82545EM Gigabit Ethernet Controller Specification Update

June 6, 2006

The *82545EM* Gigabit Ethernet Controller may contain design defects or errors known as errata that may cause the product to deviate from published specifications. Current characterized errata are documented in this Specification Update.

8. 1.5V Regulator Control Circuit Start Up

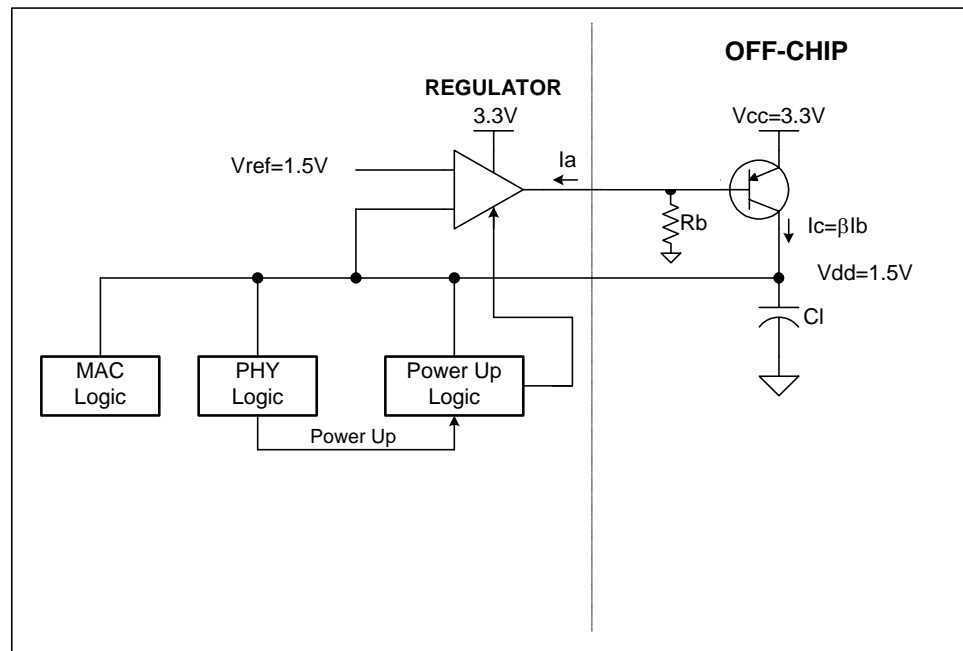
- Problem:** The 82545EM products contain on-chip LDO voltage regulation controllers for both 1.5V and 2.5V. The 1.5V regulator control output, CTRL_15, sometimes powers up in a high impedance state due to a digital portion of the feedback-control circuit which requires 1.5V to be present to operate correctly. The rate of occurrence of this problem may appear to vary from device to device or with different PNP transistors.

- Implication:** When drive is absent on the CTRL_15 output, only leakage current from the CTRL_15 output will be present. Depending on the amount of leakage current and the gain (Beta) of the external PNP transistor, there may be insufficient collector current ($I_C = I_B * \text{Beta}$) to adequately supply the 1.5V rail, and the 1.5V regulator circuit may not turn on. The 1.5V rail requires a minimum collector current of 5 mA to be generated and a 1.5V rail voltage of at least 600 mV to ensure that the digital portion of the circuit turns on correctly.

When the 1.5V regulator control output fails, the 2.5V regulator control output(s) may also fail, driving the 2.5V supply toward either 0V or the 3.3V rail. The absence of one or both of the 1.5V and/or 2.5V supplies prevents the Ethernet controller from operating correctly.

- Workaround:** The regulator control output is Ball A18 on the 82545EM controller. Intel's original reference designs showed two external resistors, R1 and R2, in this circuit. The workaround completely removes R2 and replaces it with another resistor, Rb, connected between the CTRL_15 output and ground.

For the 82545EM A-1 step: $R_b = 15 \text{ K}\Omega$ with a $\pm 5\%$ tolerance.

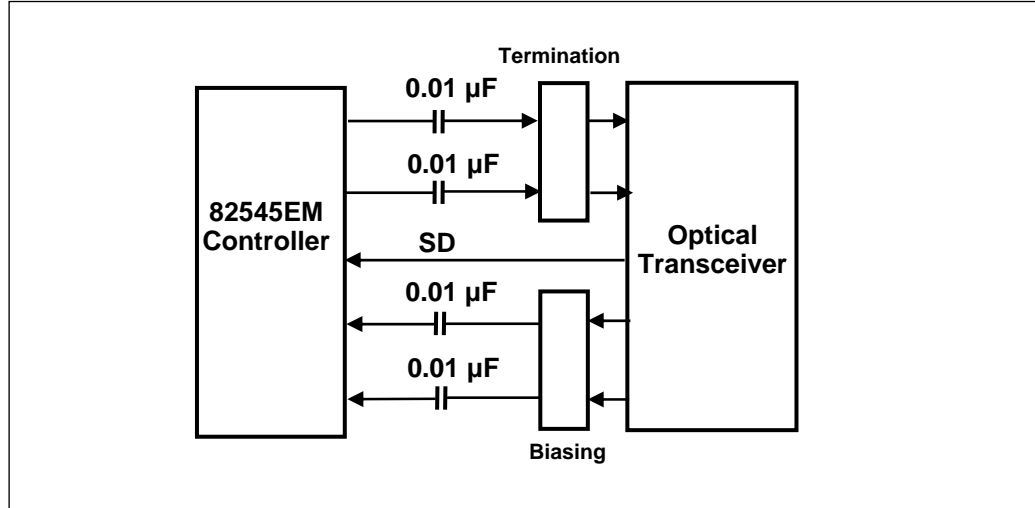
Problem: The schematics attached to this Specification Update supercede those in the original design guides. The schematics have not changed after the last Specification Update (0.5).

For the 82545EM Controller, the 0.5 revised schematic dated Sept. 24, 2001 is attached. This schematic did not change since the last Specification Update (0.6). Please note the following errors and omissions:

- The Gigabit Ethernet controller may be referred to as “Kenai 64”, “Anvik”, or “82546EB” on some of the sheets. The correct part reference is 82545EM.

- Some of the sheets refer to “Port 1.” Since the 82545EM controller is a single-port device, these references are irrelevant.
- The circuitry attached to the CTRL_15 pin requires modification for an erratum described elsewhere in this document.

- Ball A8 should be re-labeled as TEST# and have the pull-down resistor removed. This change is also described elsewhere in this document.

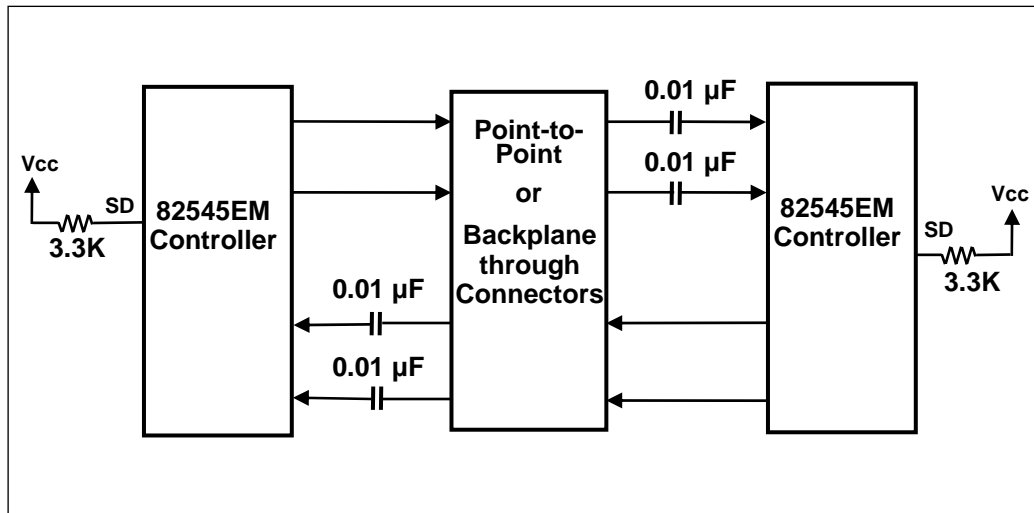
82545EM controller fiber-based applications will use the SERDES interface to drive a 1000BASE-SX or 1000BASE-LX optical transceiver as illustrated in the above figure. The 82545EM controller is internally terminated, so no external termination is required.

Alternatively, the 82545EM may be used in short haul gigabit backplane data applications without transceivers and optical fibers. No special termination is required because the 82545EM device is internally terminated. The figure below illustrates a gigabit backplane or point-to-point circuit based on either the 82545EM device:
